Access Compliance Report Public Rights-of-Way (Pedestrian Signals)

Main Street: **ANTONIO_PKWY** Cross Street: **TERRACE_RD** Location: **NE**

ADA ID: **SGRK211115163451** Signal Type: **One Push Button-Non APS** Overall Compliance: **No** Severity Scores: **BTN 1: 35** **BTN 2: N/A** **No BTN: N/A**

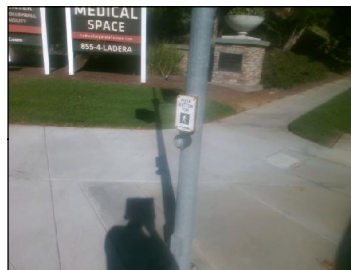
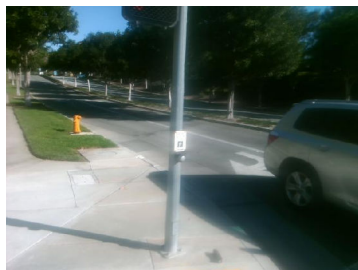
OC Std/PROW: R404.2, R404.3, MUTCD 4e.08

Possible Solutions: Replace Signal Push Button With APS Button. Remove and Replace Clear Space.
